**MANSFIELD MIDDLE SCHOOL
ROOF REPLACEMENT AND PHOTOVOLTAIC PROJECT
205 SPRING HILL ROAD
STORRS, CT 06268**

State Project No. 078-0069 RR
State Project No. 078-0070 PV

DATE: May 2, 2021

The following changes to the Drawings and Project Specifications shall become a part of the Drawings and Project Specifications; superseding previously issued Drawings and Project Specifications to the extent modified by Addendum No. 2.

ROOF HATCH DETAIL

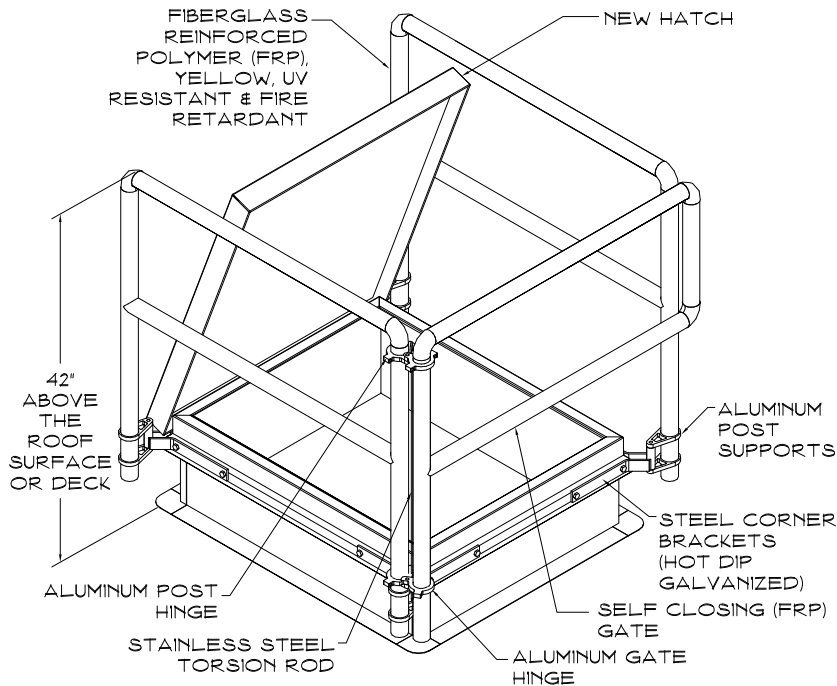
INSTALL HATCH AT NEW LOCATION ON ROOF "H" COORDINATE W/ OWNER & ARCHITECT FOR EXACT LOCATION.

PROVIDE 3"X3" METAL ANGLE IRON (ALL SIDES) FOR NEW OPENING IN EXISTING DECK FOR NEW ROOF HATCH LOCATION.

PROVIDE INTERIOR METAL LADDER TO ACCESS NEW HATCH. SEE DETAIL N/A2 FOR SIMILAR CONDITION.

EXIST. DECK. REMOVE PORTION OF EXIST ROOF DECK TO ALLOW NEW HATCH. COORDINATE W/ SPEC FOR SIZE.

PROVIDE TAPERED BLOCKING TO LEVEL HATCH FROM EXISTING ROOF PITCH.
